G-3837

**Subject:** Response to September 3, 2015, Geotechnical Third Party Review Letter,  
Proposed Residence, 5637 East Mercer Way, Mercer Island, Washington.

**Reference:** Geotechnical Third Party Review, 5637 E. Mercer Way, Mercer Island,  
Washington (Perrone Consulting Project #15124). Perrone Consulting, Inc., P.S.,  
September 3, 2015.

<b>Group Northwest, Inc.</b> <small>Geotechnical Engineers, Geologists, &amp; Environmental Scientists</small>			<b>SITE PLAN</b> PROPOSED RESIDENCE 5837 E. MERCER WAY MERCER ISLAND, WASHINGTON								
SCALE	1" = 30'	DRAWN BY	KJ	CHECKED BY	WC	DATE	10/28/2015	PROJECT NO.	G-3827	PLATE	1

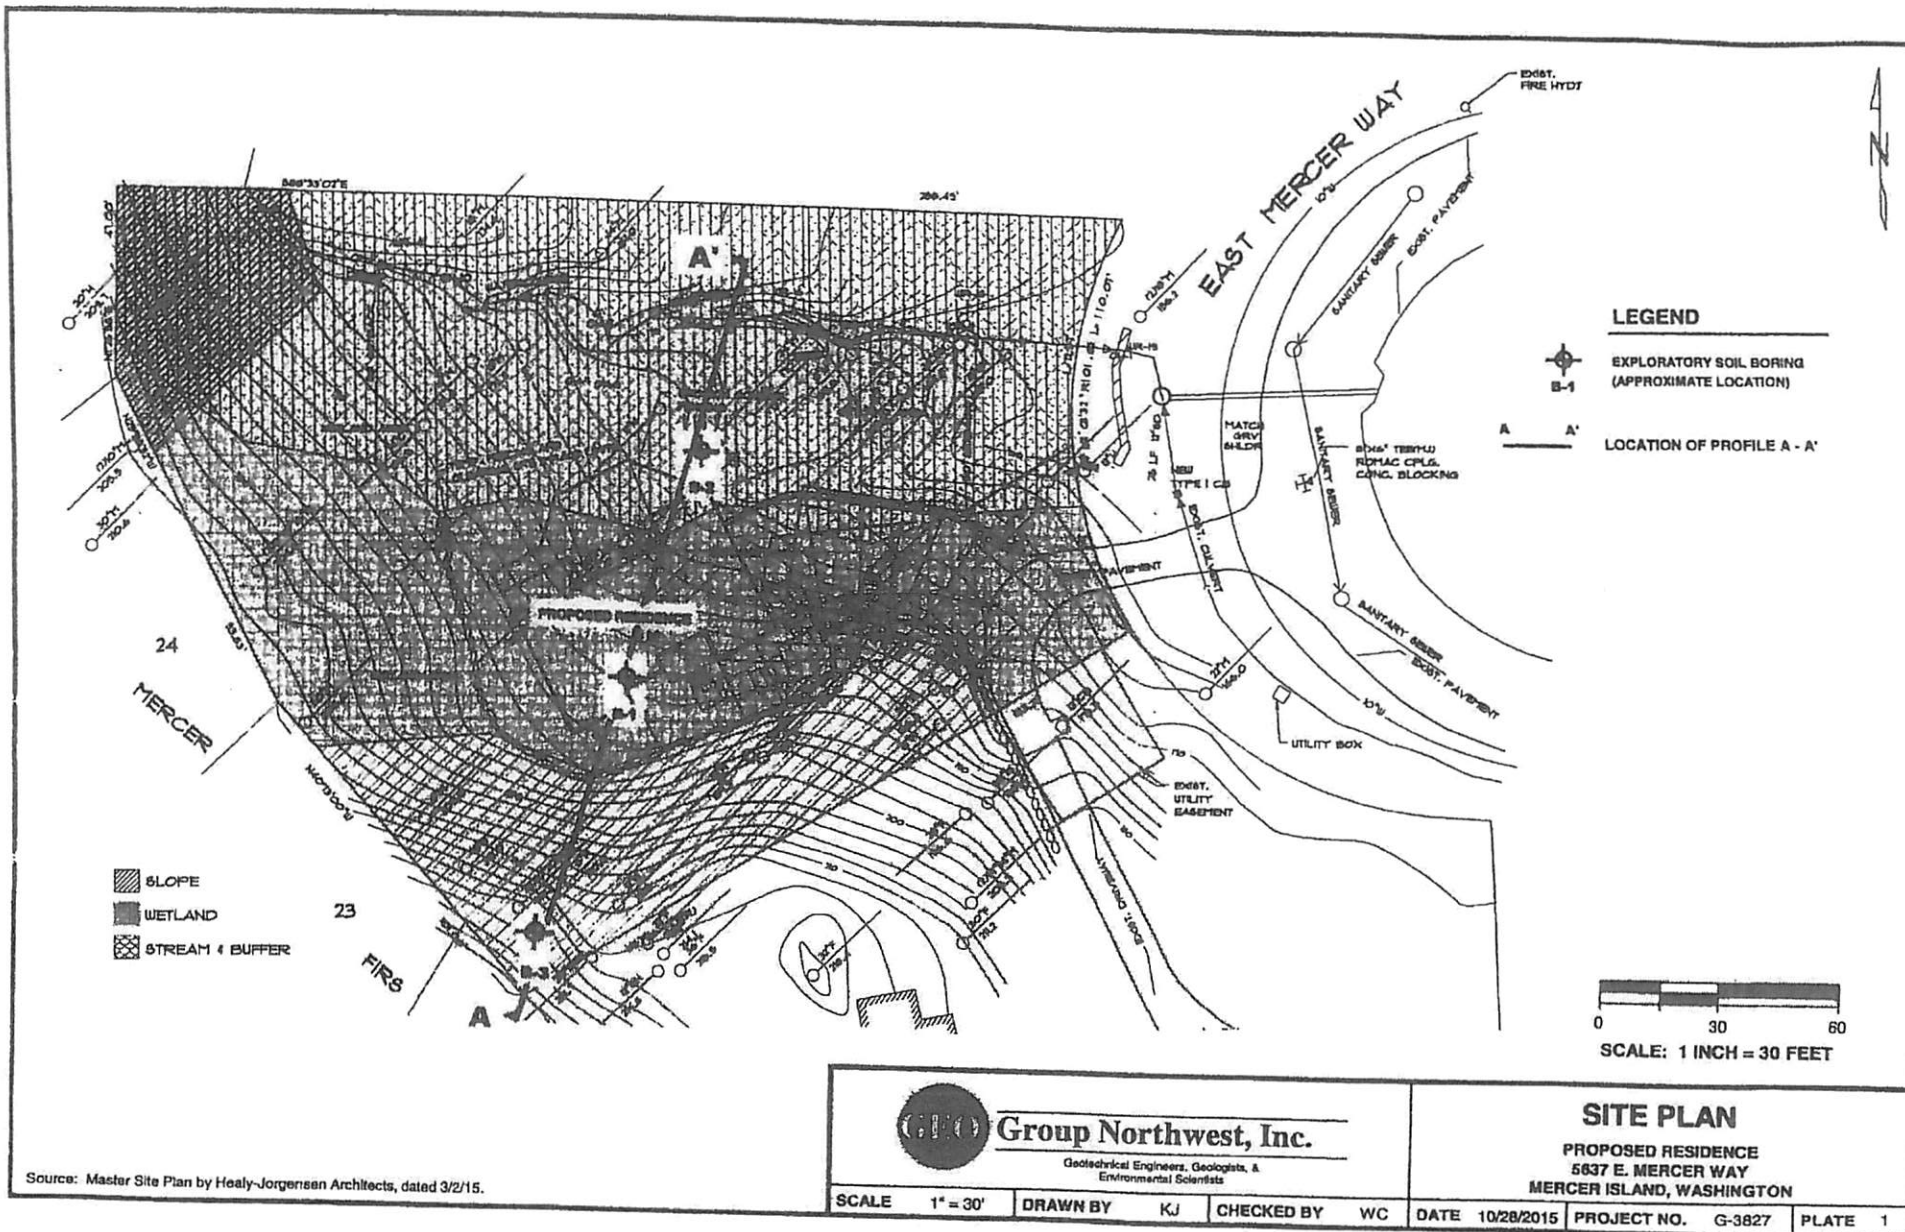
On October 2, 2015, a representative from our firm supervised the drilling of an exploratory soil boring, B-3, on the steep slope area in the southern portion of the site. The location of the borings is illustrated in Plate 1 – Site Plan. The boring was completed to a depth of approximately 31.5 feet below ground surface by using a manually-portable drilling rig equipped with hollow-stem augers.

A site plan showing the locations of the soil borings previously completed on the site (B-1 and B-2) and the additional soil boring recently completed on the site (B-3) is provided in Plate 1 – Site Plan. Also, a subsurface profile through the site (the location of which is indicated on the site plan) is provided in Plate 2 – Subsurface Profile A-A'.

**SUBSURFACE PROFILE A - A'**

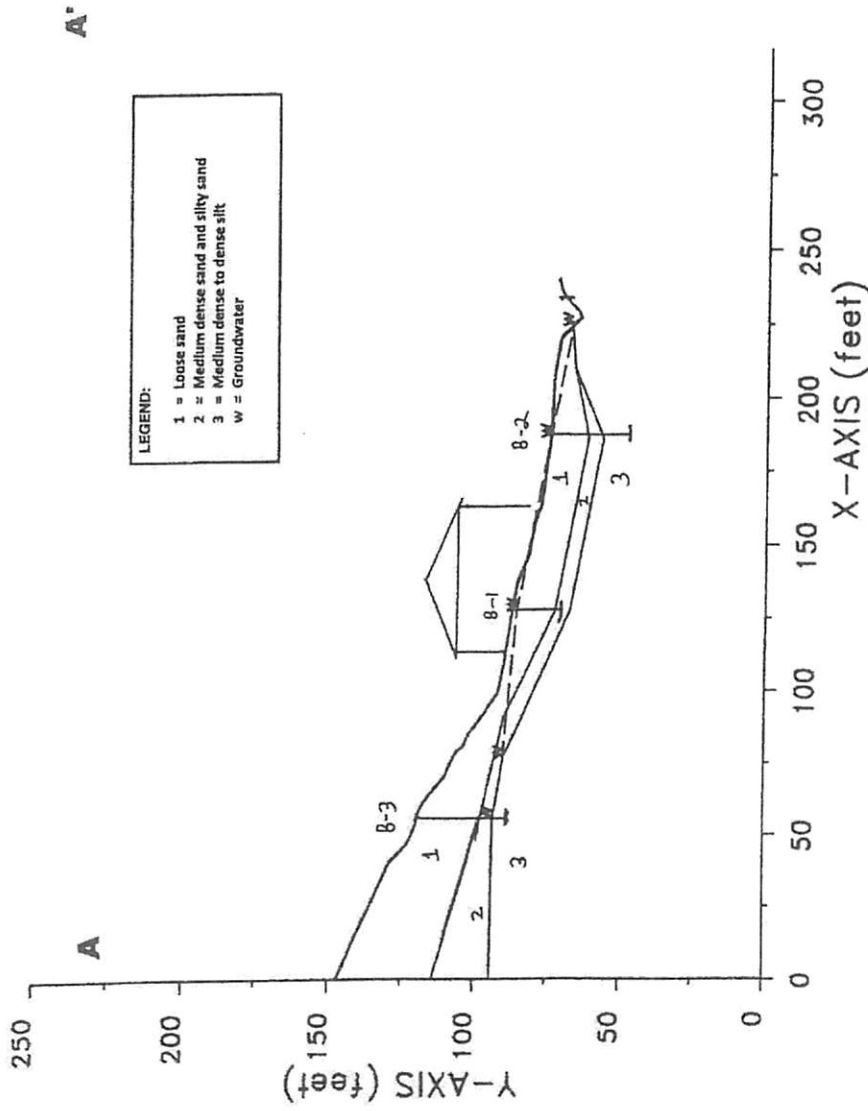
Stability analyses were performed for the site profile A-A' enclosed with this letter. The subsurface soil conditions illustrated in the profiles are based on the soil conditions logged for the borings drilled on site and our interpretation of the extent of those conditions into other portions of the profile. The interpreted soil conditions at locations other than at the boring locations are inferred based on our professional experience and judgment; the actual conditions may vary from those represented in the profile.

**SLOPE STABILITY ANALYSIS RESULTS**

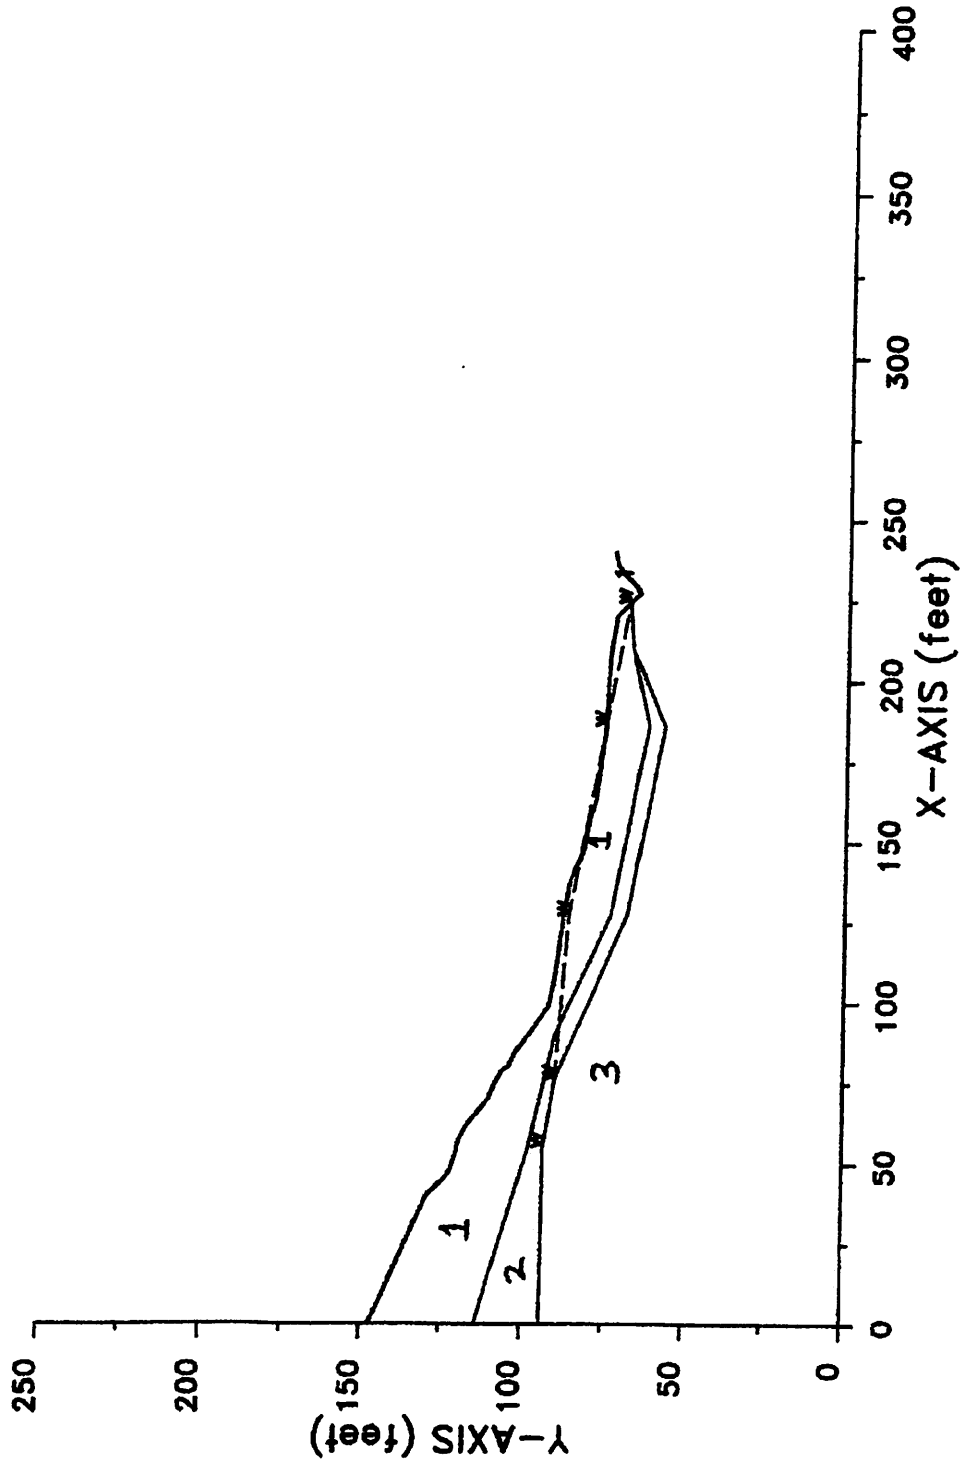
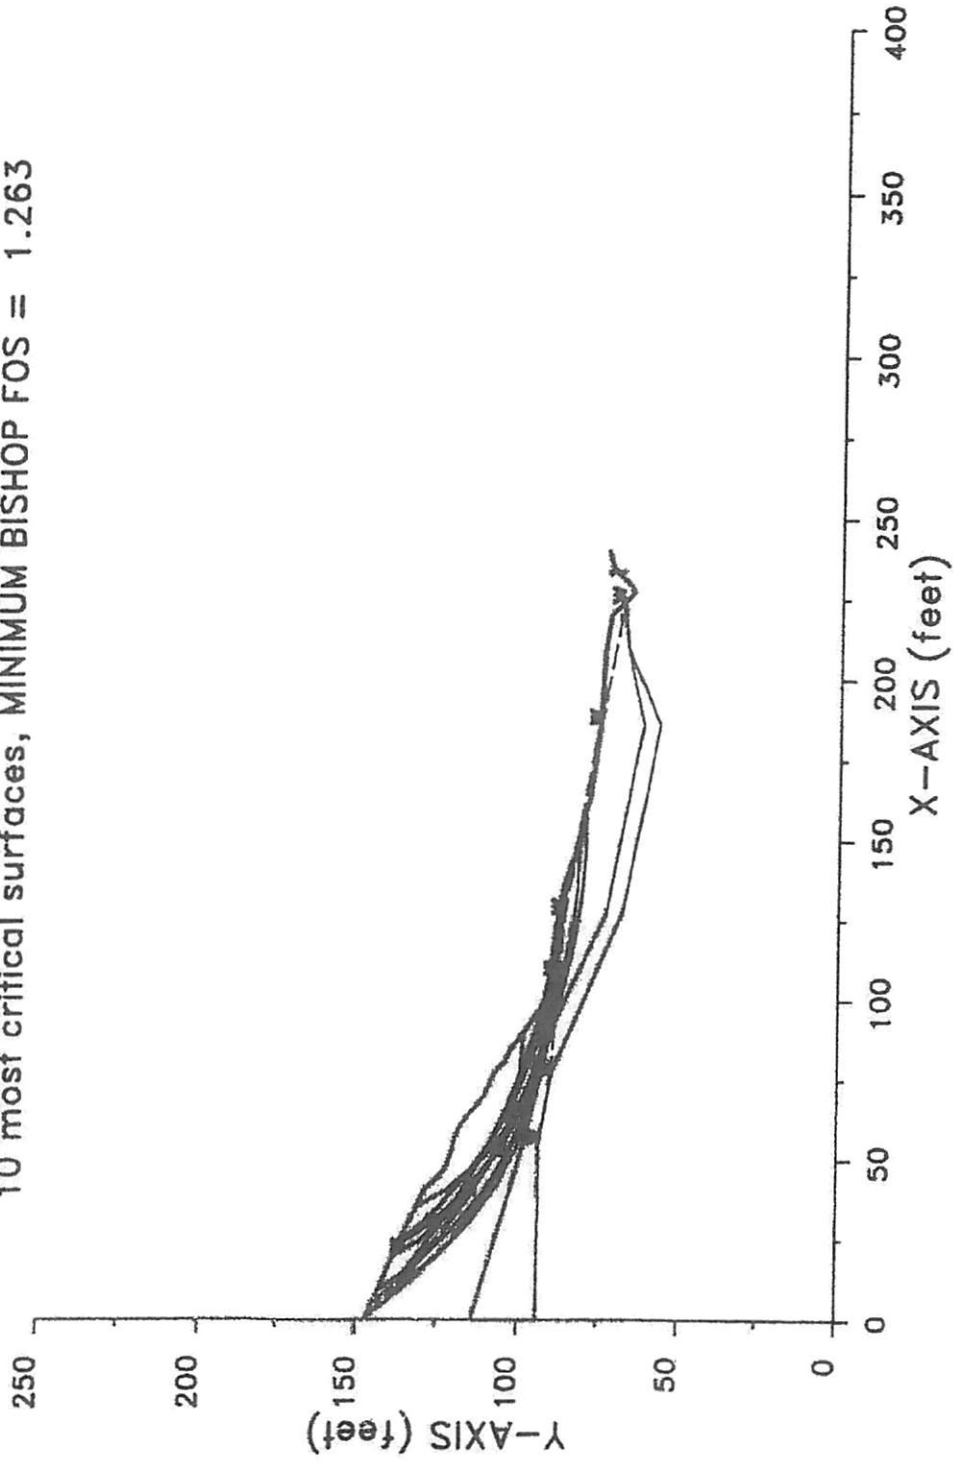
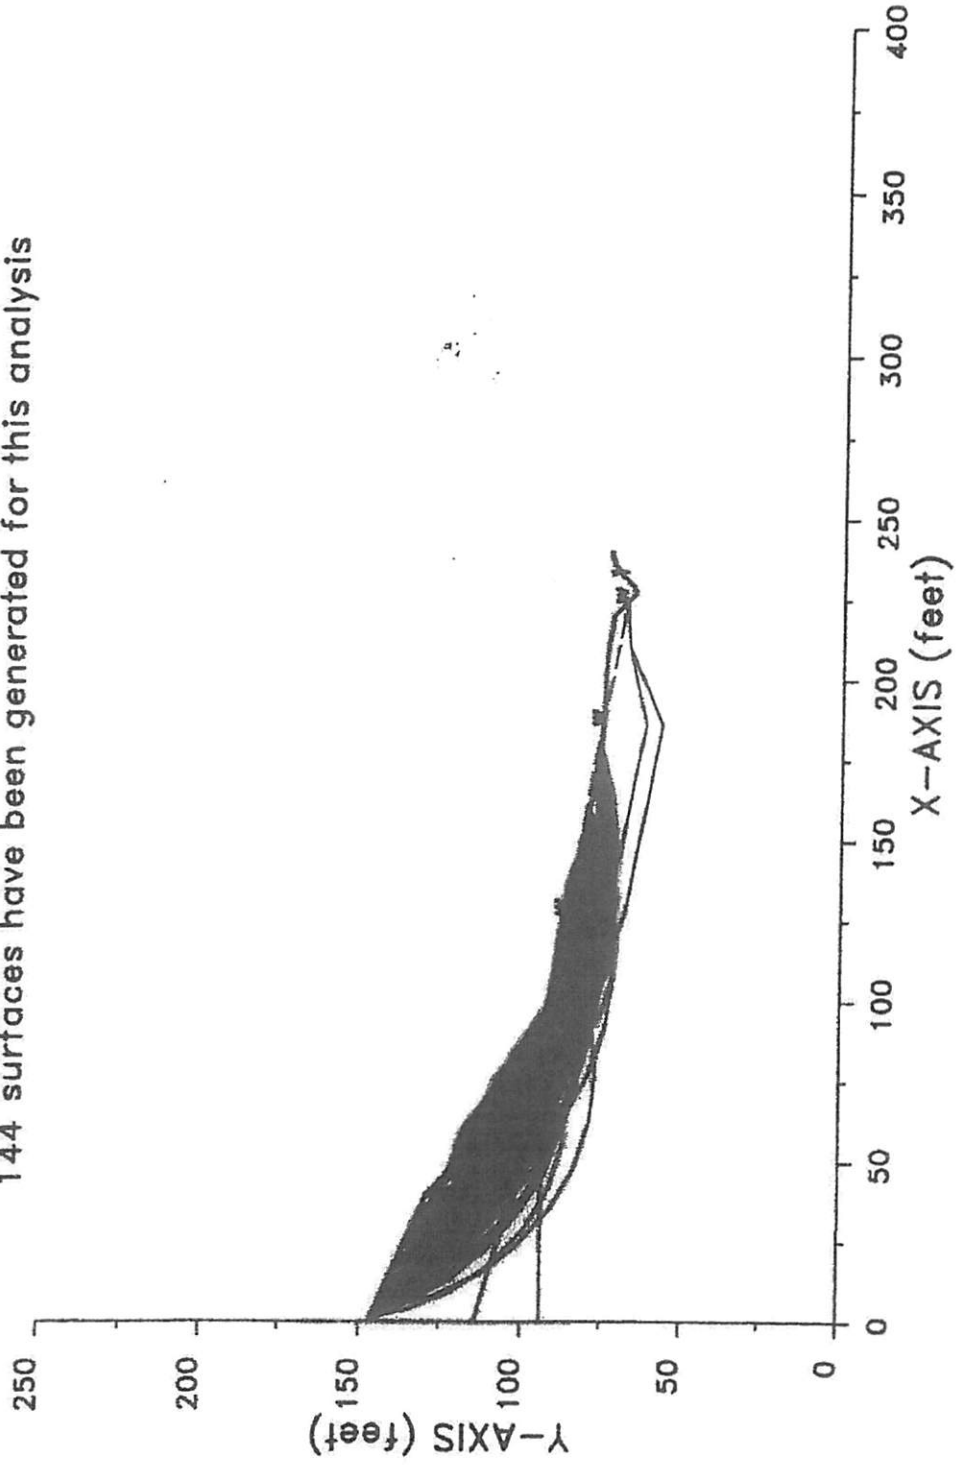
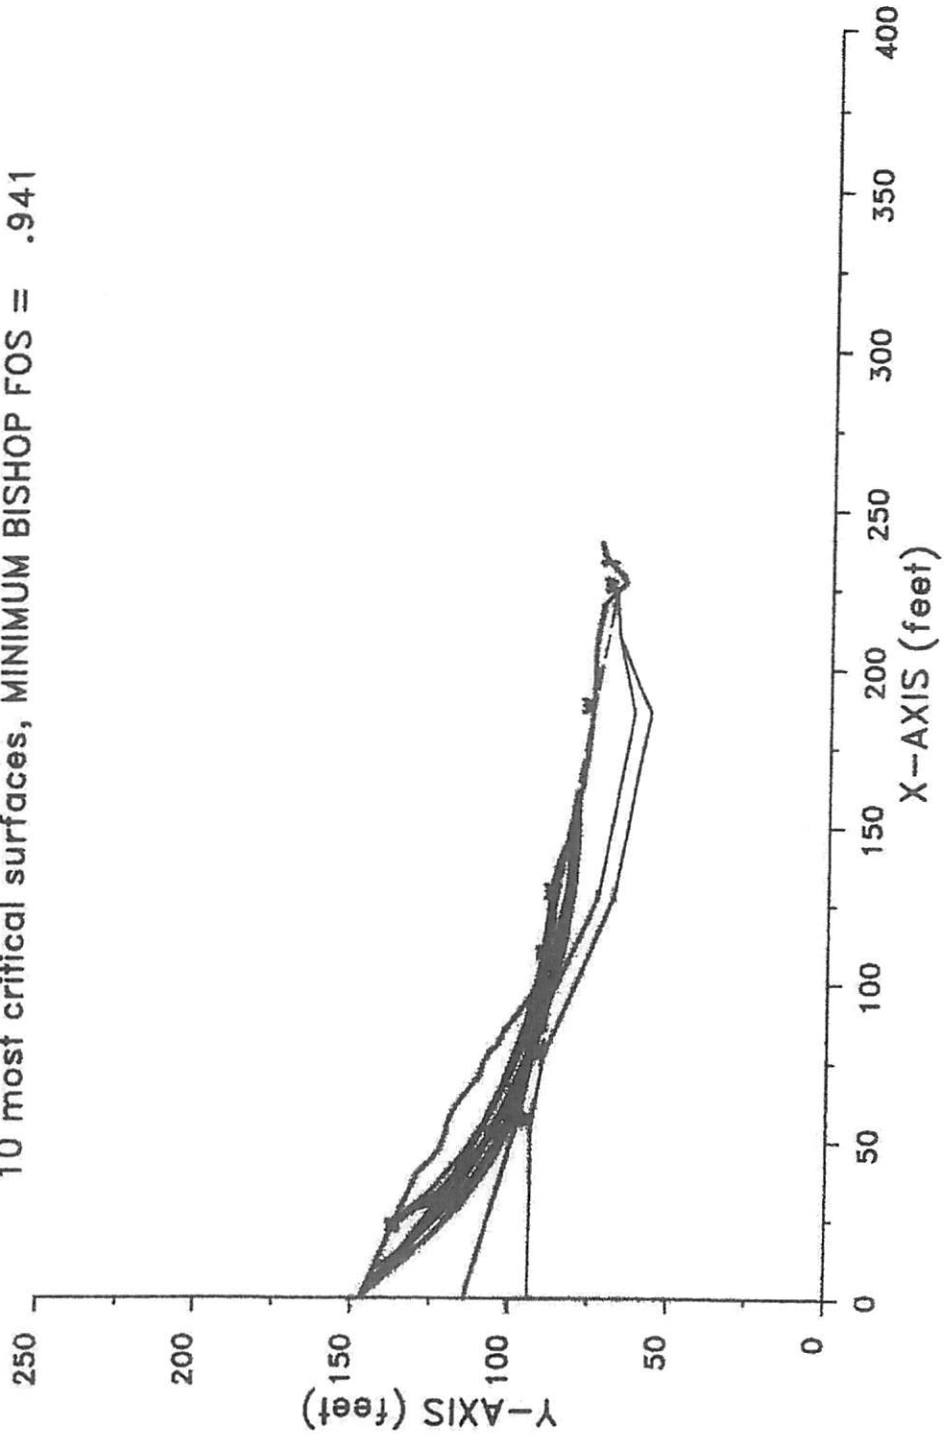
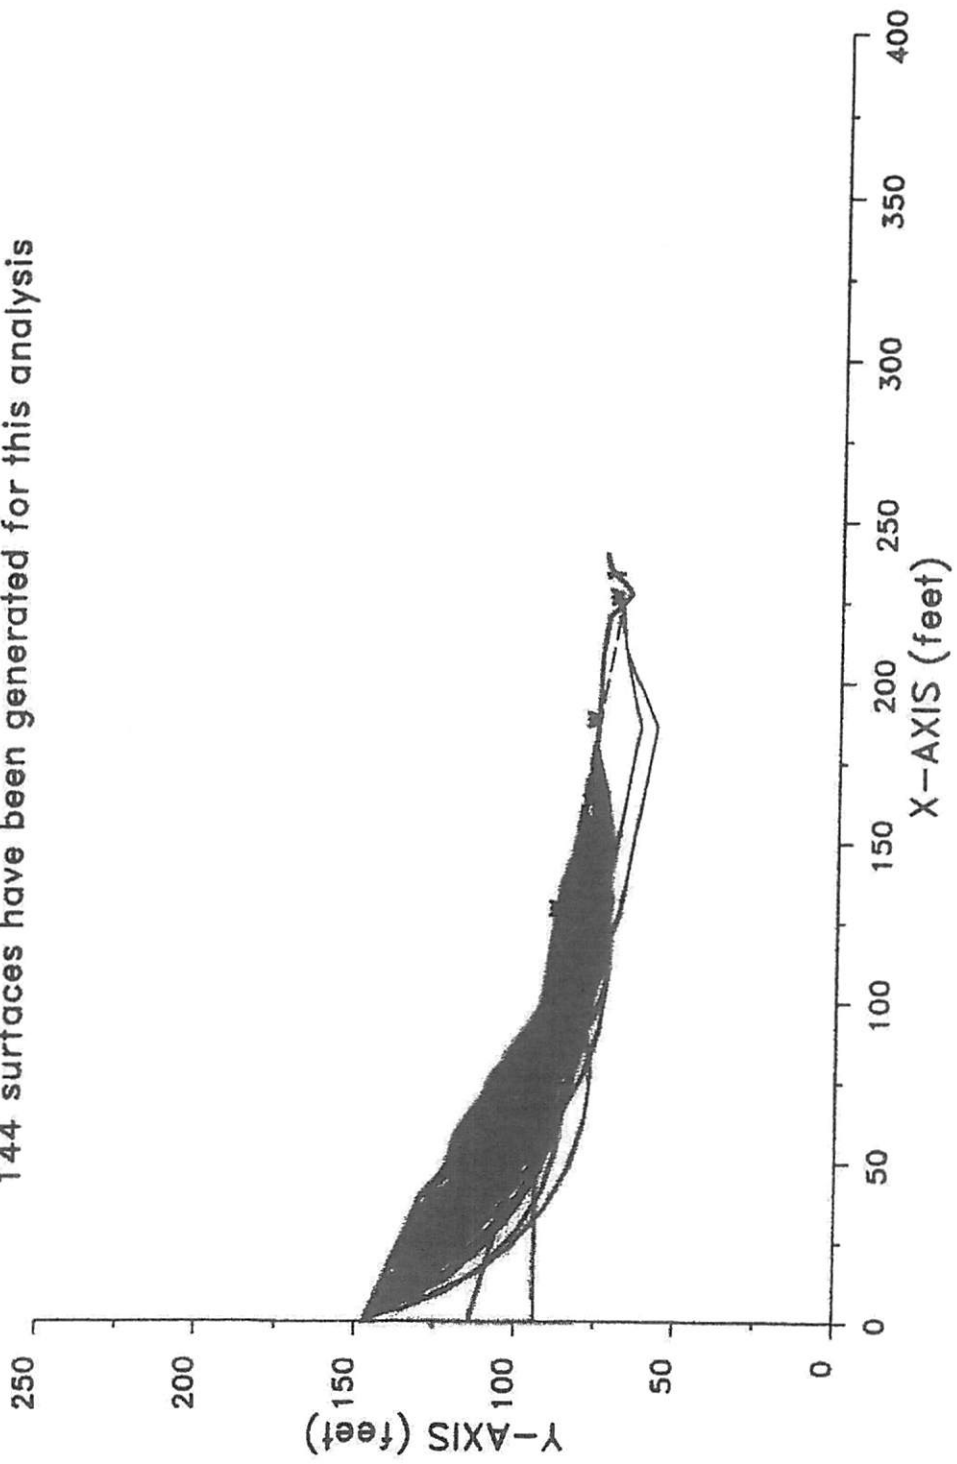
The stability analysis calculations indicate that the slope profile has an FS value of 1.26 for stability in its existing configuration for the static case, and an FS value of 0.94 for the seismic case. The most critical failure surfaces for the existing slope condition consist of arc-shaped failures that involve the loose sand soils. These failure surfaces are generally similar for the static and seismic cases. The most critical failure surfaces identified in the analyses are illustrated in the analysis plots provided in Attachment 2.

Based upon the results from the subsurface investigation and slope stability analysis that we have completed, it is our opinion that the steep slope in proximity to the proposed residence location is relatively stable in its current condition. However, based on the observed conditions, it also is our opinion that the slope is susceptible to shallow raveling or sloughing, particularly if it is disturbed by earthwork or significant clearing. With regard to larger-scale movement, we concluded that the slope has a low potential for failure in its existing condition over the short term. However, there is the potential for failure of the loose sandy soils in the slope over the long term, particularly during high-intensity seismic events or if exceptionally high groundwater levels develop in the sandy soils up the slope.

Protection of the residence from slope failure of the types identified from the slope stability analysis results can be provided by constructing an engineered catchment/retaining wall at or near the base of the steep slope south and southwest of the proposed residence location. We recommend that the wall have a minimum height of 6 feet above final grade as measured on its upslope side. We also recommend that the wall be supported using a system of small-diameter pipe piles to provide vertical support and inclined helical anchors embedded into the soils below the slope to provide lateral support.
